## ***Interactive comment on “Domestic wells have high probability of pumping septic tank leachate”*** **by J. E. Horn and T. Harter**

**Anonymous Referee #2**

Received and published: 24 October 2011

Fig. 1.

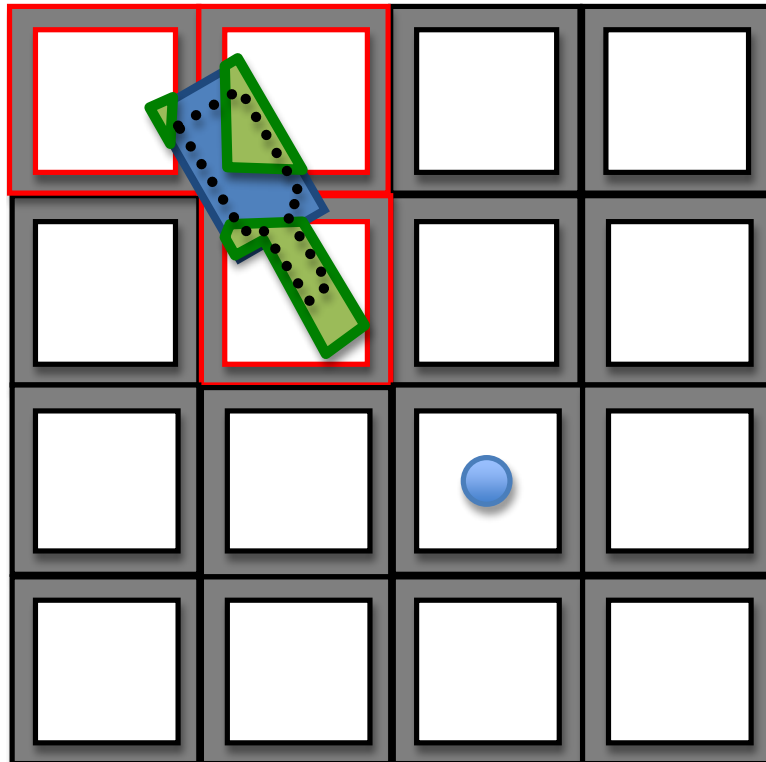
Figure 1 and 2 are not working as well to explain these ideas as they could. For instance, it would be easier to understand Figure 2 if the capture zones shown were the same relative scale as they are in Figure 1. It would also be very helpful to show Figure 2 at an expanded scale, which would allow the authors to show the full overlap of the capture zone across multiple lots. I've attached a different version of Figure 1 and 2 that I think captures the authors' intentions:

The original capture zone is shown as the dashed line. The capture zone "footprint" is shown as the solid shape. The cell array is shown, with buffers at the property boundaries grayed out. The red cells are those intersected by the capture zone footprint. The areas within the cells that are overlapped and are outside the buffer are shown in green. The areas in the footprint that cannot contain the center of a drain field are shown in blue. The probabilities per cell would be computed as the green area for each cell divided by the grey area for each cell.
